MANCHESTER TOWNSHIP PLANNING COMMISSION AGENDA

RE: 3875-3885 Board Road – Office & Storage
Preliminary/Final Subdivision & Land Development Plan
Manchester Township Plan #2025-07
Engineer's Project No. 0841.3.02.A1
Response #1

Re: 3875-3885 Board Road – Office & Storage
Preliminary/Final Subdivision & Land Development Plan
Manchester Township Plan #2025-07
Engineer's Project No. 0841.3.02.A1

We have reviewed the above-referenced Preliminary/Final Subdivision Plan and Preliminary/Final Land Development Plan, submitted by PennTerra Engineering, Inc., dated June 3, 2025. We offer the following comments:

SCALE	AS NOTED
DRAWN BY	ESL
CHECKED BY	AWA
CONTACT	AWA
DATE	09.04.25
FILE NAME	1356.5-FSD-1
JOB NO.	1356.5
SHEET NO.	FSD-2
SHT. 2 OF 4	2

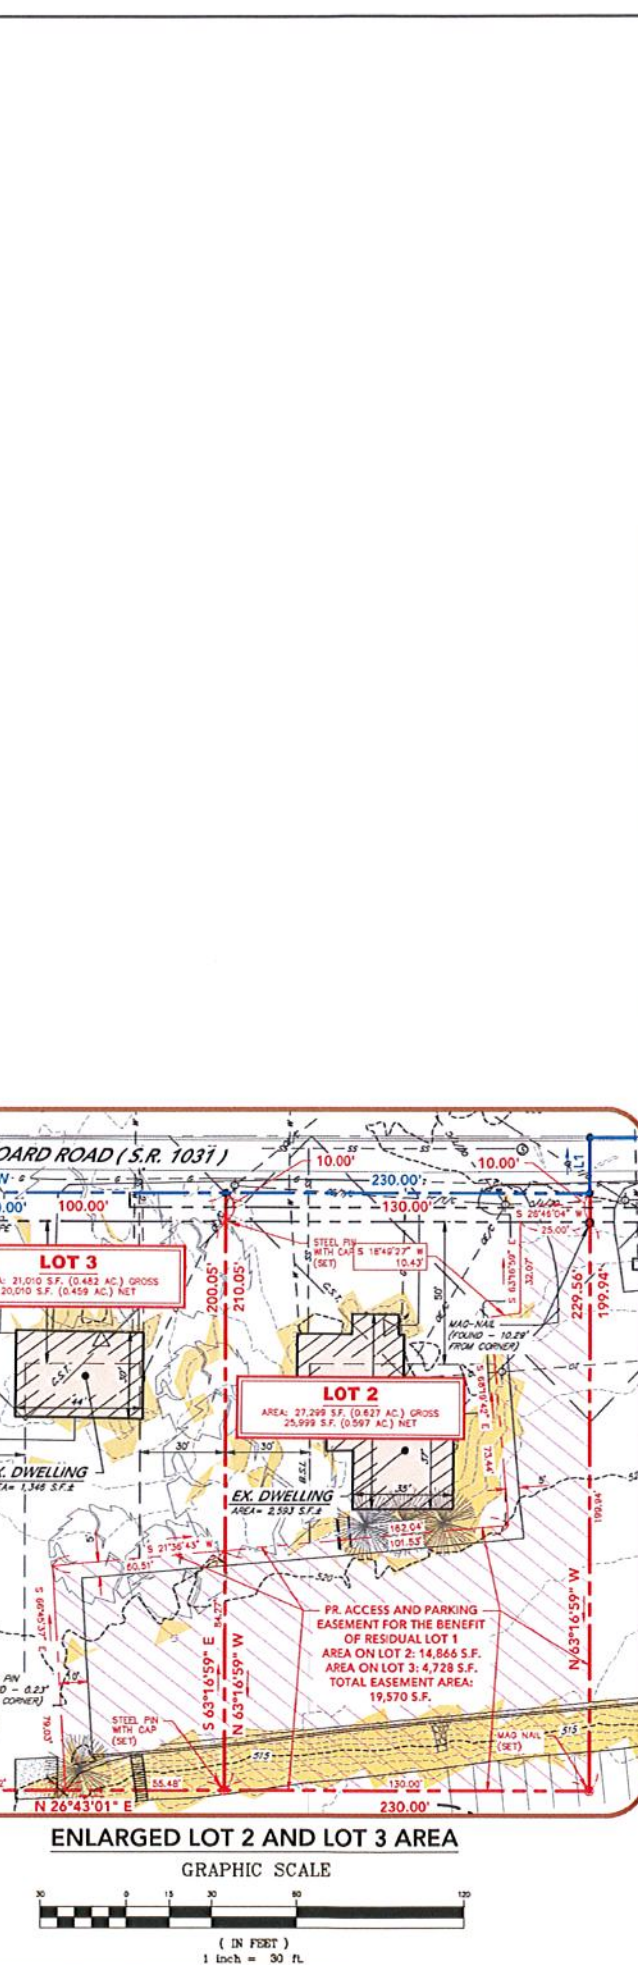
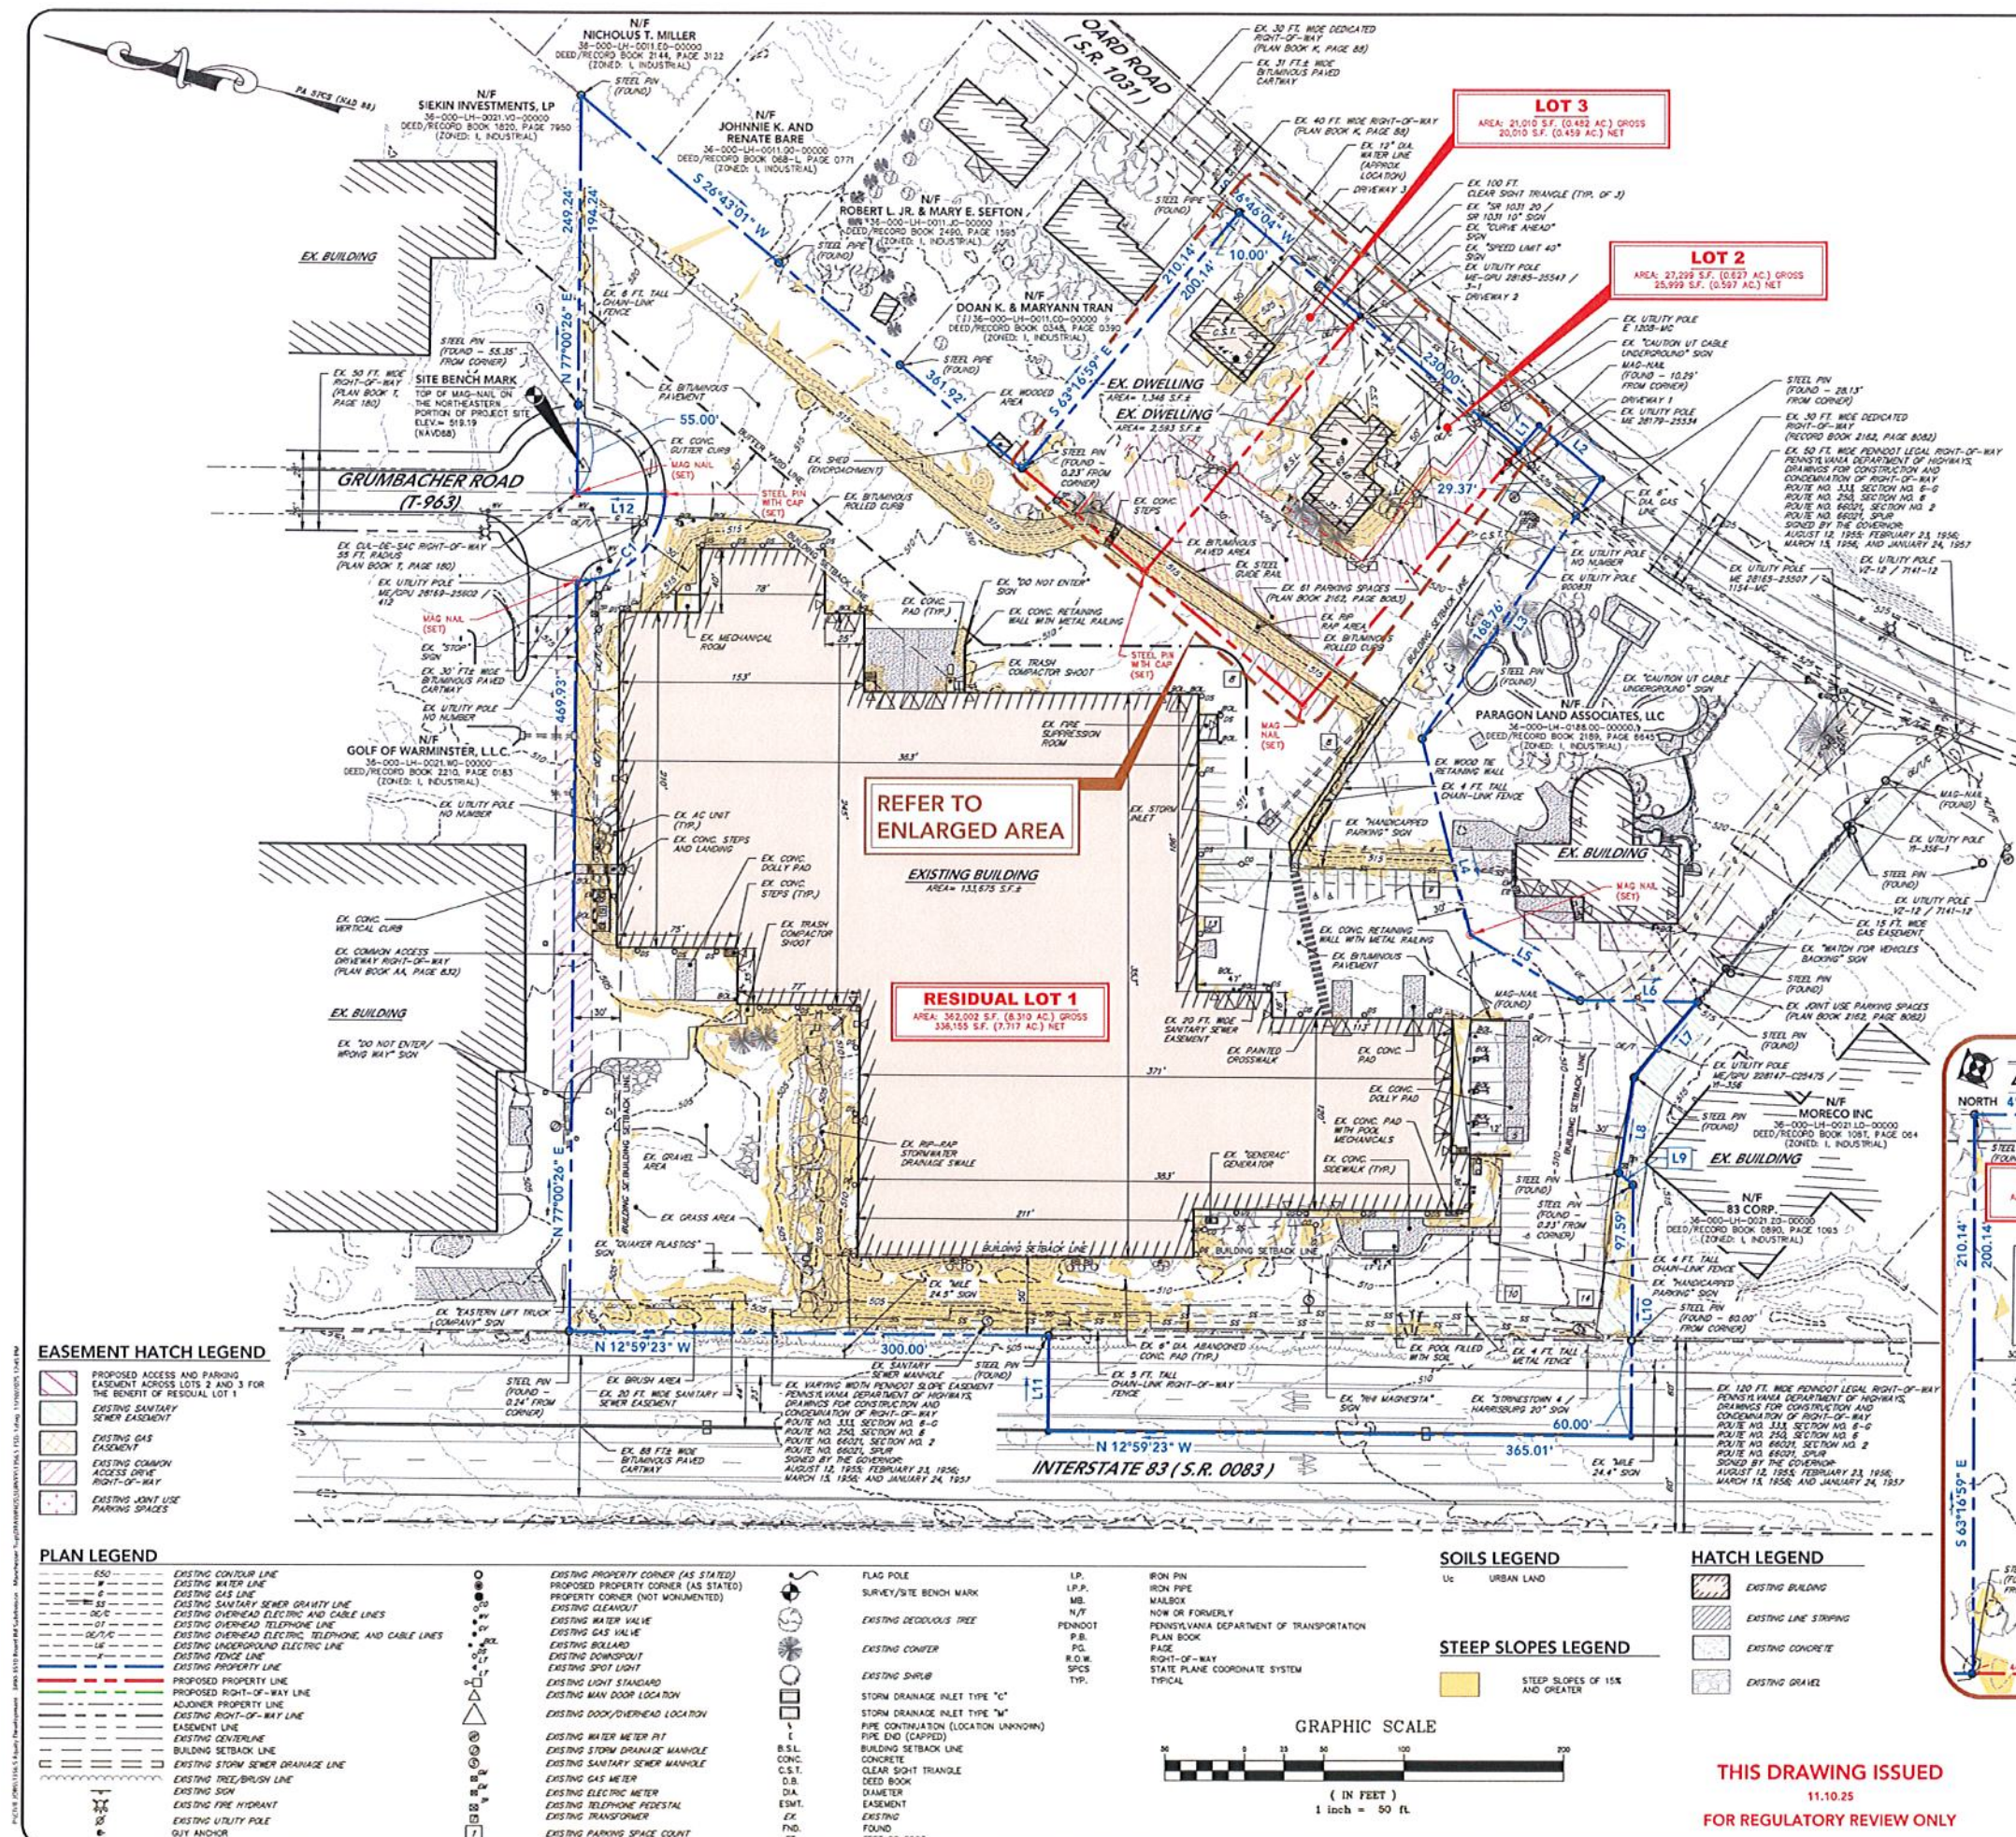
6. Dimensions have been provided for the existing buildings on the Project Site. Please refer to plan sheets FSD-2 and FSD-3.
7. The Clear Sight Triangles have been dimensioned on the plan. Please refer to plan sheets FSD-2 and FSD-3.

DRIVEWAY SIGHT DISTANCE MEASUREMENTS

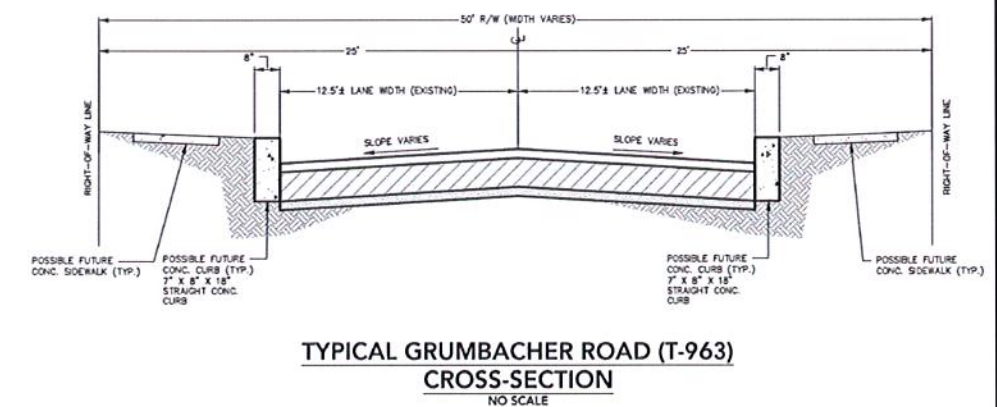
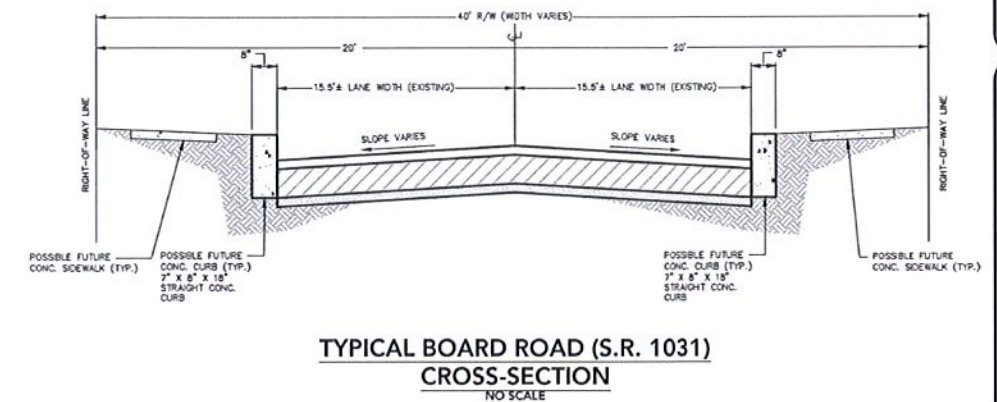
4. General Note #17 has been removed from the Title Sheet, plan sheet FSD-1, regarding a Title Search not being completed for the Project Site.
5. Safe Stopping Sight Distance measurements have been completed for the three (3) existing driveways onto Board Road. Please refer to "Driveway Sight Distance Measurements" provided on plan sheet FSD-4.
